## DEVELOPMENT APPLICATION ASSESSMENT REPORT

<b>Application Number:</b>	DA2021/0301
----------------------------	-------------

<b>Responsible Officer:</b>	Thomas Burns
<b>Land to be developed (Address):</b>	Lot 1 DP 1076755, 12 Corniche Road CHURCH POINT NSW 2105
<b>Proposed Development:</b>	Alterations and additions to a dwelling house including carport
<b>Zoning:</b>	E4 Environmental Living
<b>Development Permissible:</b>	Yes
<b>Existing Use Rights:</b>	No
<b>Consent Authority:</b>	Northern Beaches Council
<b>Land and Environment Court Action:</b>	No
<b>Owner:</b>	Richard Geoffrey Frank Morris
<b>Applicant:</b>	JJ Drafting

**Figure 2: envelope non-compliance highlighted below**

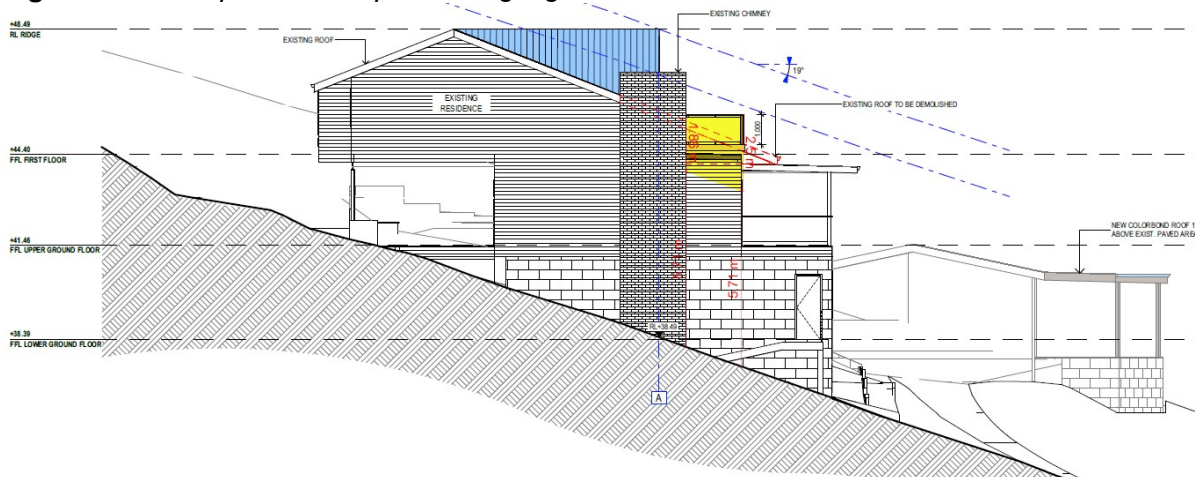
The control requires buildings to remain within an envelope determined by projecting planes at 45 degrees, when measured from 3.5m above the existing ground level at side boundaries. A portion of the proposed development protrudes outside of the prescribed building envelope, which fails to comply with the numeric requirement. The extent of the non-compliance is depicted in Figure 2 below.
